ELEVATIONS

Project:
 Cross Street Development
 Brew Pub and Apartments
 Aurora, Illinois 60506

Sheet:
 Details and Window Details

ELEVATIONS

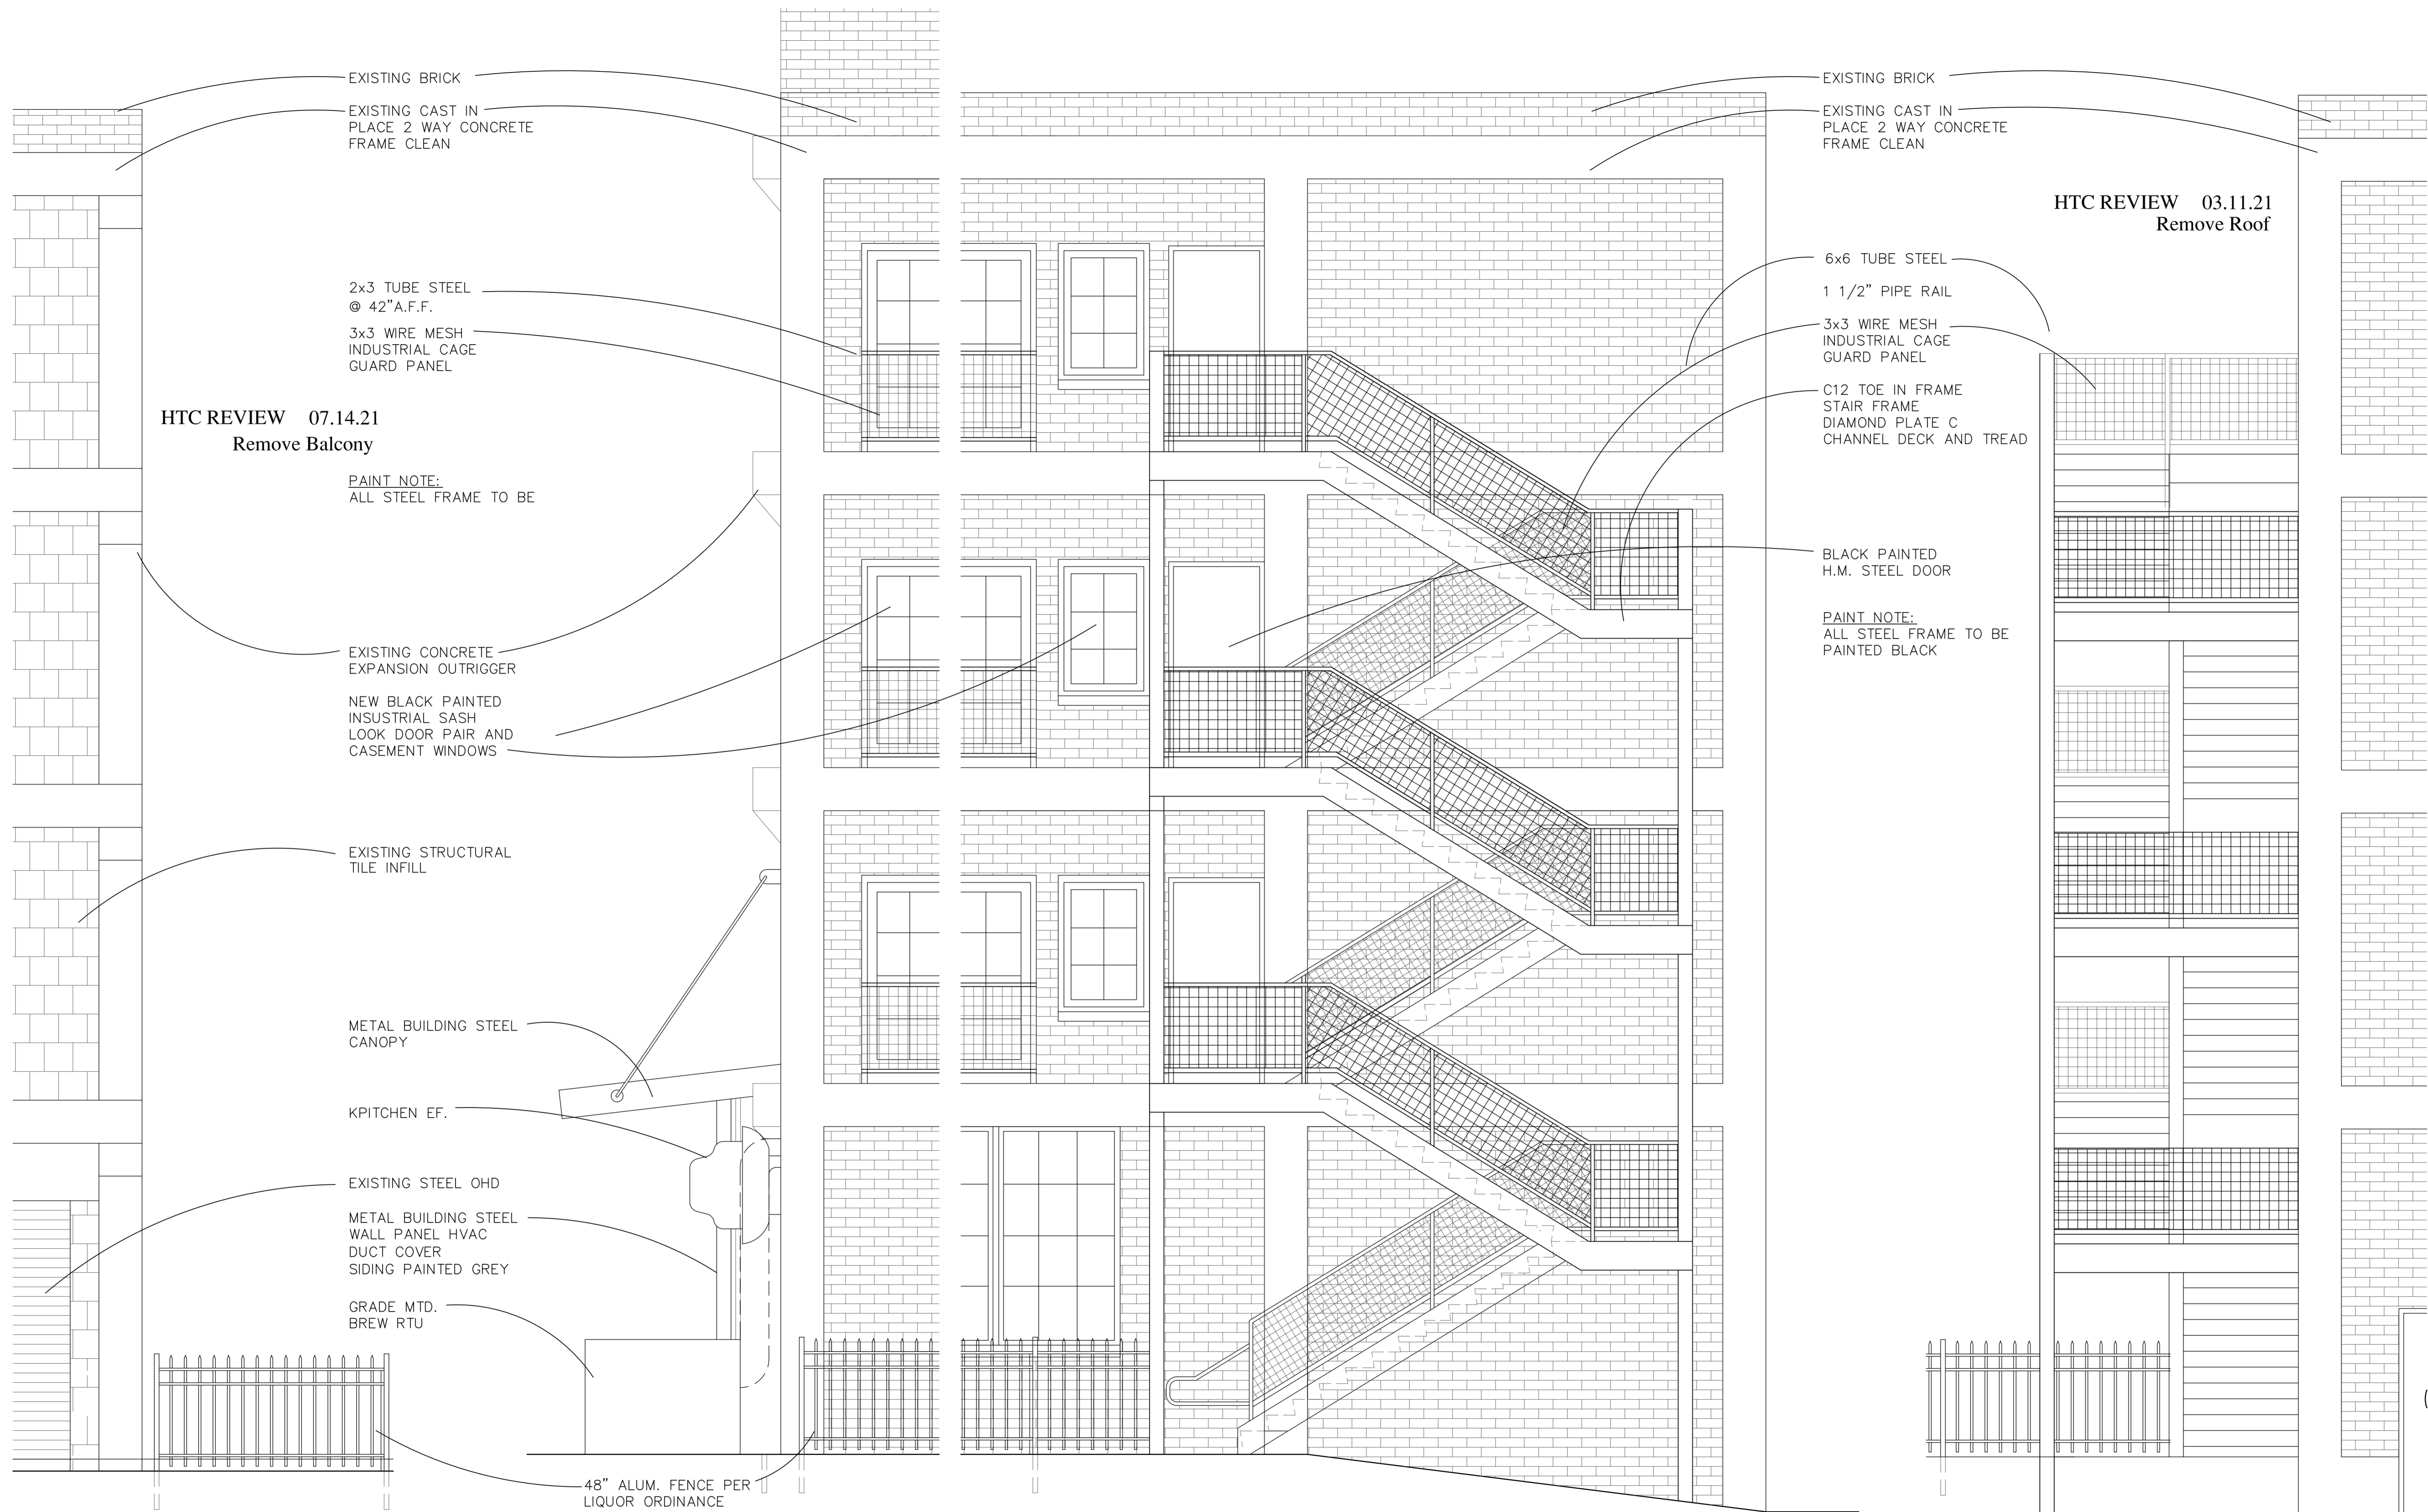
HTC REVIEW 07.14.21
Remove Balcony

HTC REVIEW 03.11.21
Remove Roof
